Date: September 13, 2023  
To: All Vendors  
Subject: Addendum #1

**REFERENCE: P066-23 RE-SOLICITATION OF 15KV METAL CLAD SWITCHGEAR  
FOR THE WATER PORT & LOMA ALTA SUBSTATIONS**

NOTE:  
BUS HARDWARE TO BE TORQUED  
AT 45FT/LBS

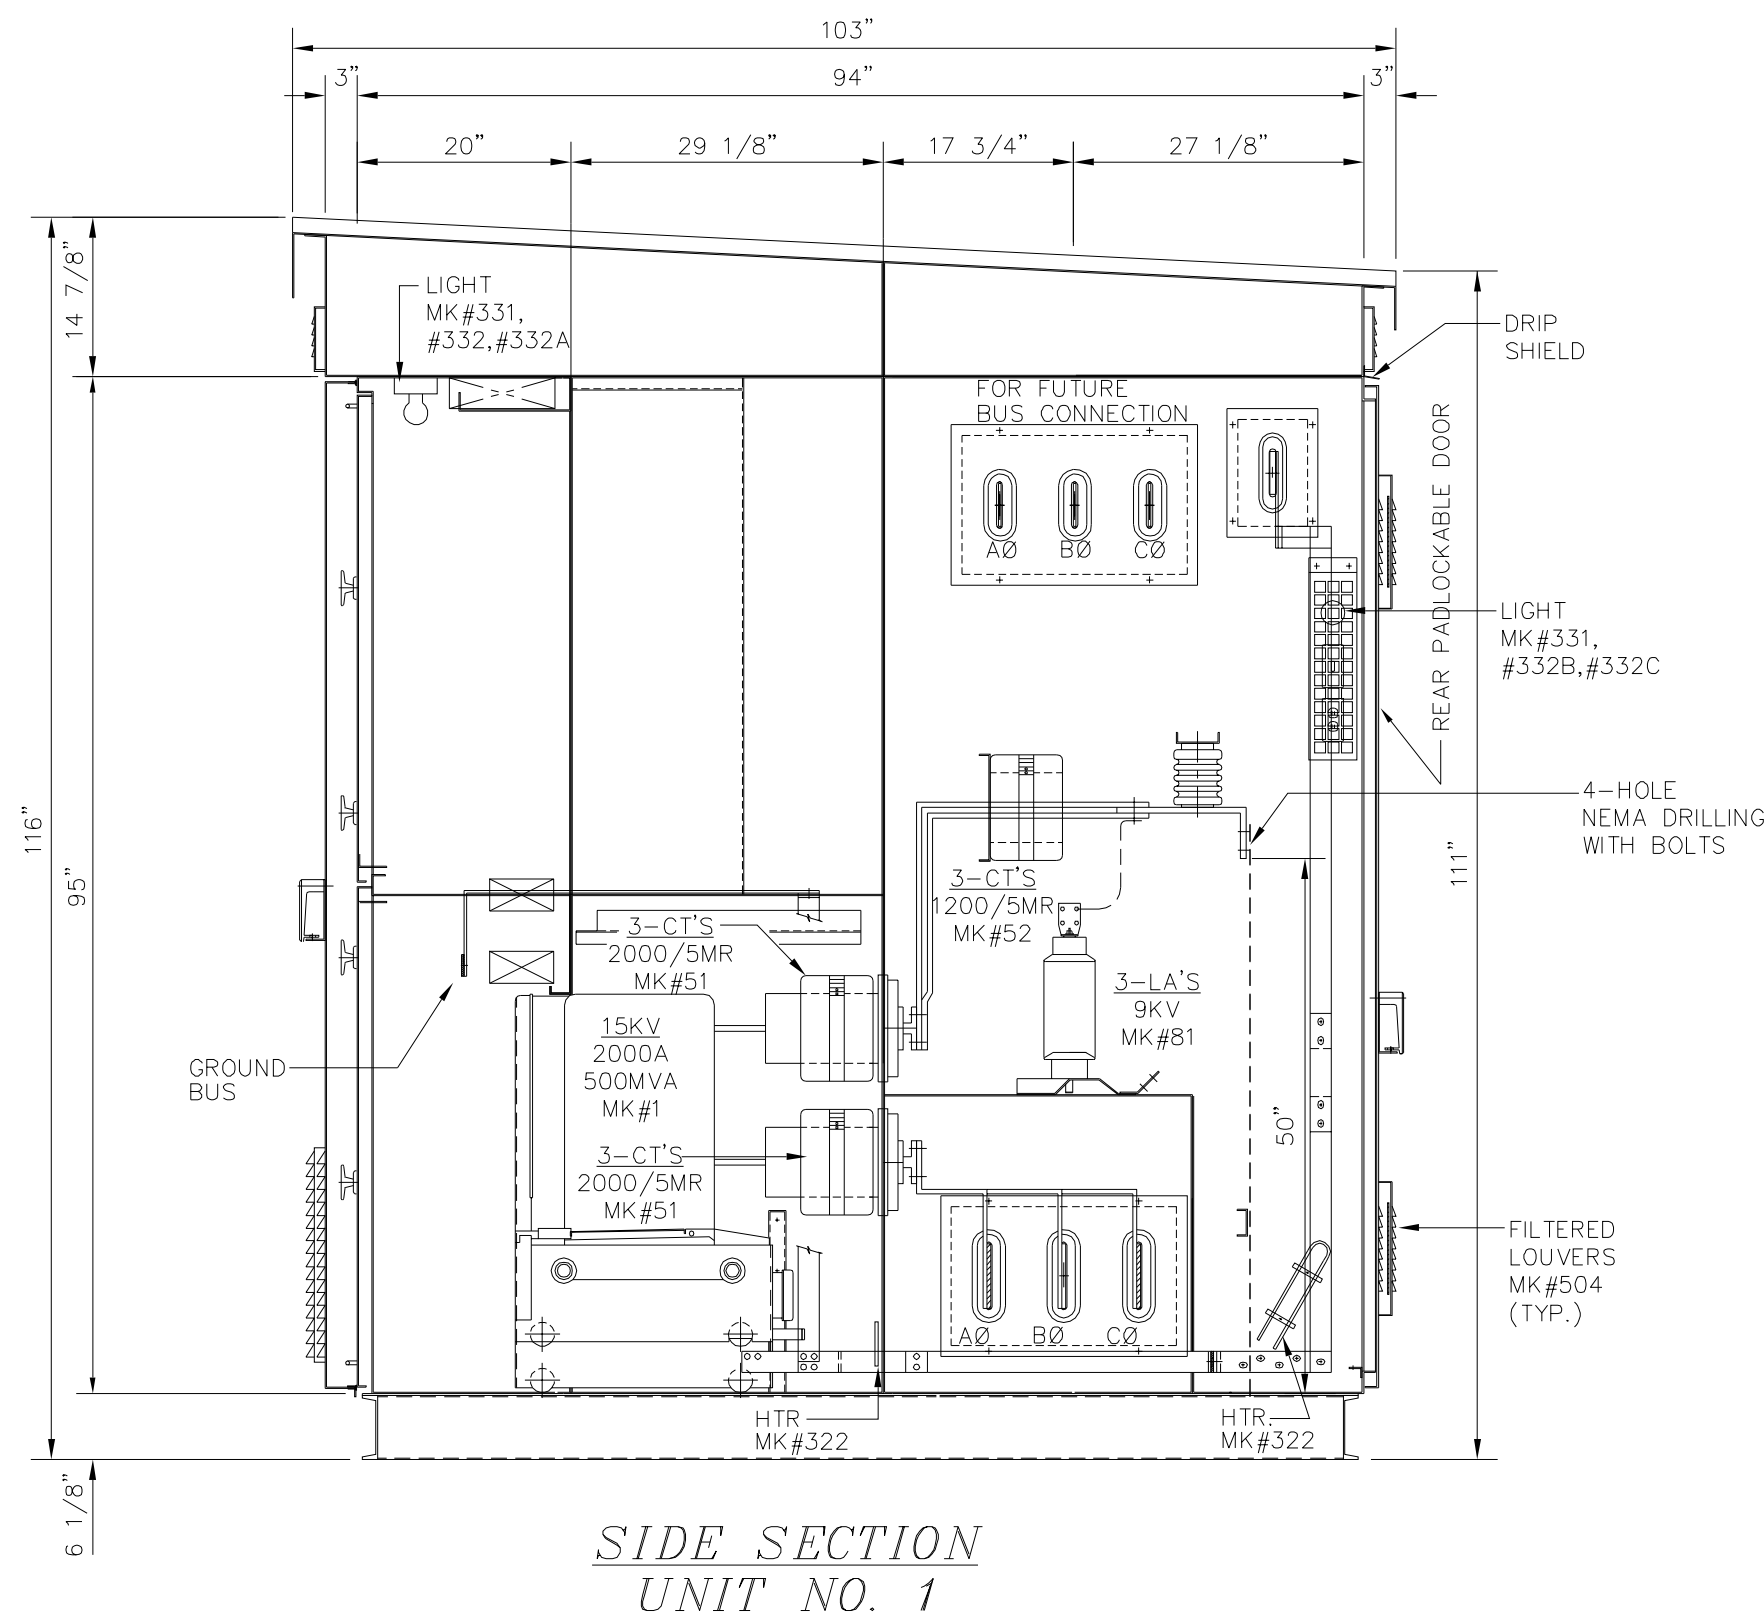
**Question 4:** Would you be able to confirm which type of switchgear you currently have on your system? Will there be a pre-bid site walk that we can attend?

- c) Will these line-ups need to be delivered at the same time or what is the allowable time between deliveries?
- d) The specifications state, these line-ups will need to mate and connect up to existing gear and match the existing foundations. If this is still the case, is there any information on the existing items?

**Answer 4:** Existing Water Port equipment is a 6 cubicle, 15 kV outdoor non-walk in metal-clad switchgear. Refer to attachment "Water Port Substation - Existing Metal-Clad Switchgear (6 Cubicle)". There is no Pre-bid site walk through for this RFP.

- a) The requested 15 kV outdoor non-walk in metal-clad switchgear lineup consists of seven vertical sections (cubicles). Refer to drawing 1003-D-1030A.
- b) Refer to answer for question #6 below.
- c) Refer to answer for question #1 above.
- d) Refer to attachment “Water Port Substation - Existing Metal-Clad Switchgear (6 Cubicle)” and “P06623 WP\_021O\_(1003-D-1024)”.
